Video/RGB Monitor Service Bulletin

Model: GVM2000, GVM2100, GVM2020

No. 1

Subject: Q3504 and Q3507 Protection From Over Voltage

A-BOARD
SOLDER SIDE

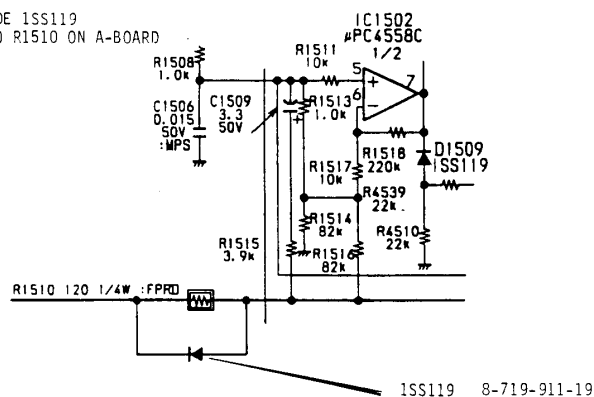
Symptom:
(111) No Picture.

Solution: Check Q3504 (H. Out) and Q3507 (Converter. Out) for shorts. If shorted, perform the following to prevent possible re-occurrence.

SOLDER DIODE 1SS119
PARALLEL TO R1510 ON A-BOARD
